Project	IEEE 802.16 Broadband Wireless Access Working Group < http://ieee802.org/16 >	
Title	Enhancement of BS Initiated Handoff Algorithm for 802.16e	
Date Submitted	[2003-11-07]	
Source(s)	Changhoi Koo Jung Je Son Samsung Electronics Suwon, Kyeonggi-do Korea	Voice: [+82-31-279-5091] Fax: [+82-31-279-5130] chkoo@samsung.com jungje.son@samsung.com
Re:	Response for Call for Comments of IEEE802.16e-03/07r4 Call for Comments of IEEE802.16e-03/07r4 is announced at 80216e-03_23.	
Abstract	Contains the enhanced element about BS initiated Handoff of 802.16e	
Purpose	Discussion and adaptation in a proper position for enhancement of 802.16e handoff algorithm	
Notice	This document has been prepared to assist IEEE 802.16. It is offered as a basis for discussion and is not binding on the contributing individual(s) or organization(s). The material in this document is subject to change in form and content after further study. The contributor(s) reserve(s) the right to add, amend or withdraw material contained herein.

Enhancement of BS Initiated Handoff Algorithm for 802.16e

Figure D.9 – HO process by BSS request

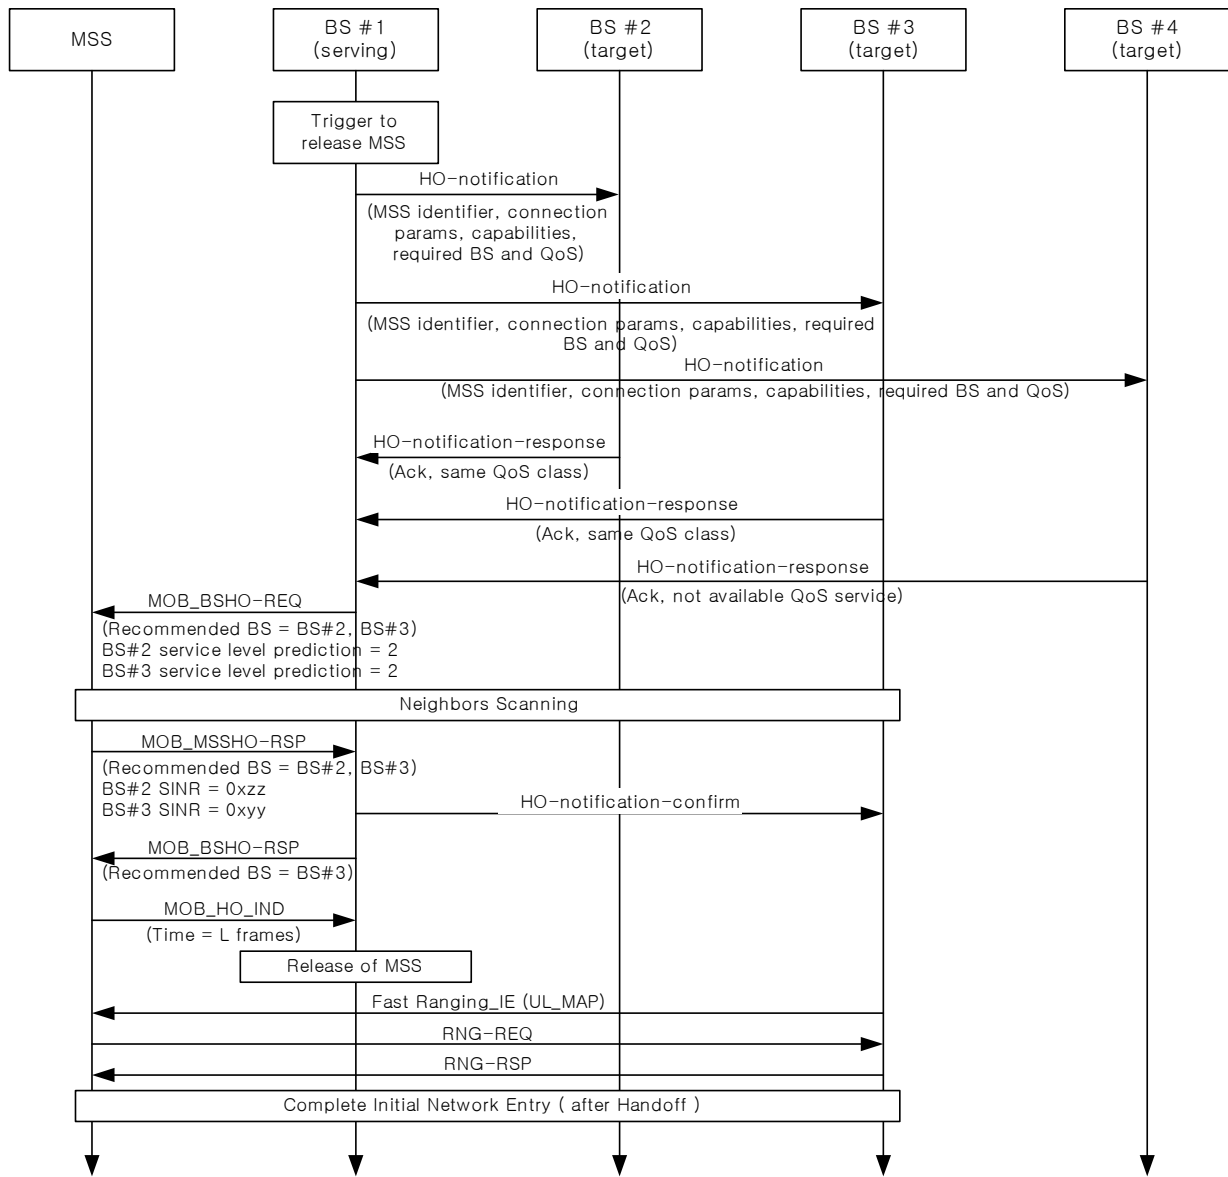
In page 60, replace Figure D.9 with:

Figure D.10—HO process by BSS request and MSS decision of target BS

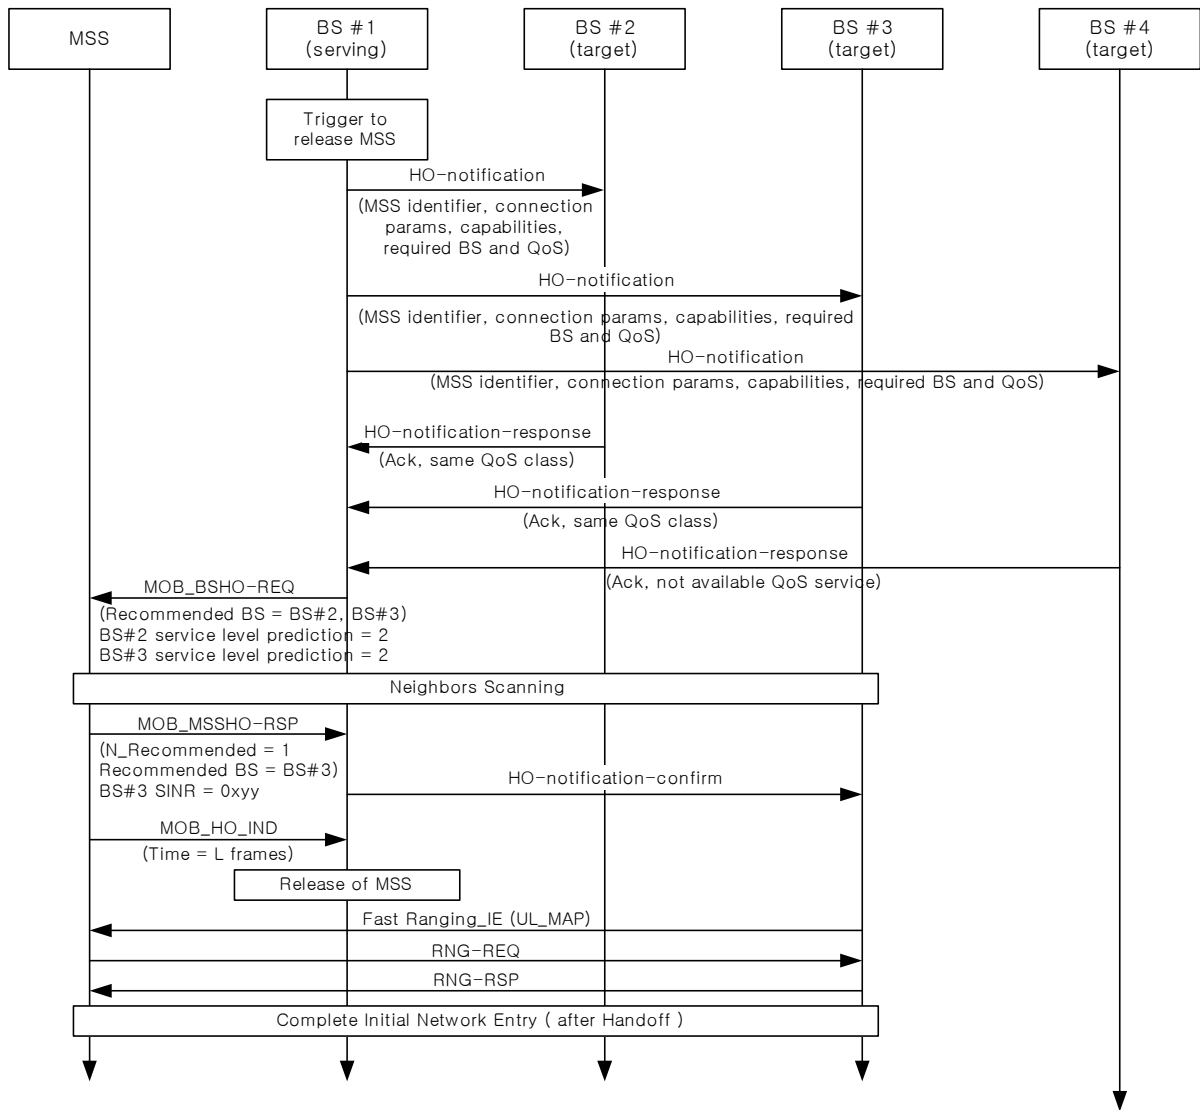
In page 60, Add following Figure after Figure D.9 at section D.1 with:
